RE: **Lot 17 Block 6, Volcano Cliffs, Unit 22, SAD 227**
6508 Kimmick Rd. NW
Grading and Drainage Plan
Engineers Stamp Date 10/4/18 (D10D003M17)

Based upon the information provided in your submittal received 10/4/18, this plan is approved for Grading Permit.

DRAINAGE AND TRANSPORTATION INFORMATION SHEET (REV 6/2018)

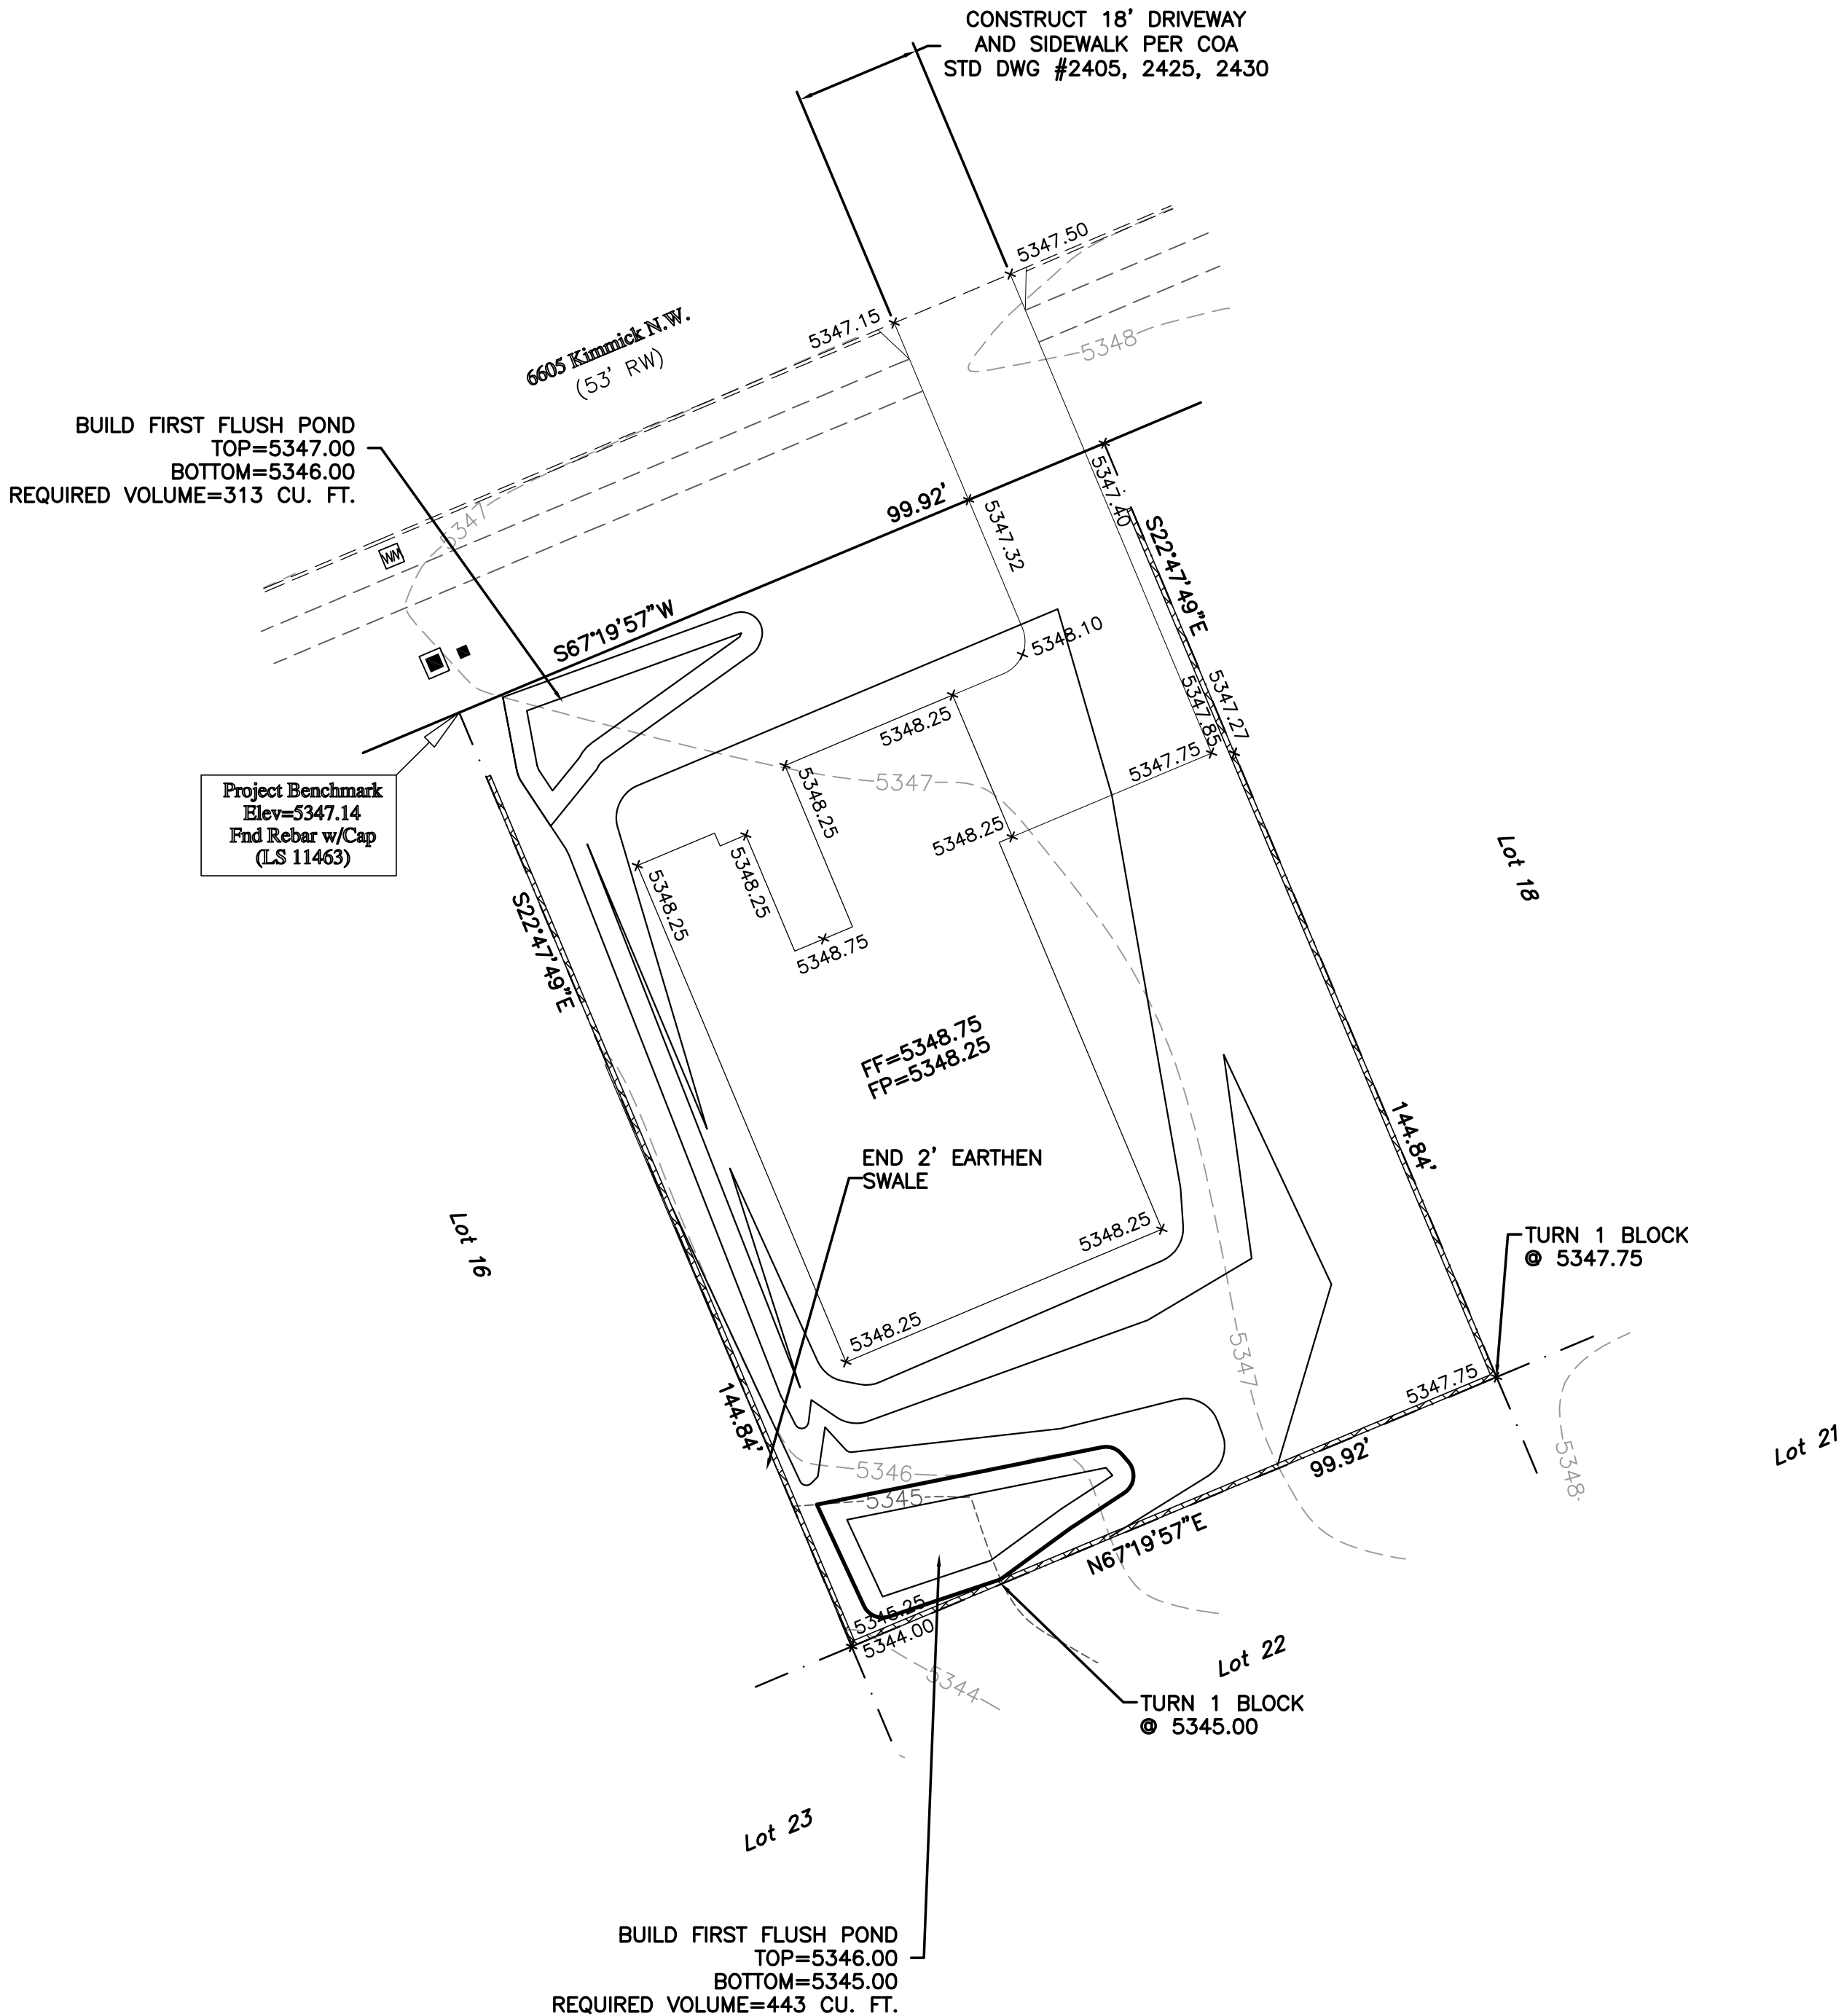
Prior to Building permit approval a Pad Certification will be required, provided by the Engineer or a registered Land Surveyor.

Reiterate to the Owner/Contractor that a separate permit for a garden/retaining wall must be obtained with the approved G&D plan and Pad Certification.

Prior to Certificate of Occupancy release, Engineer Certification per the DPM checklist is required.
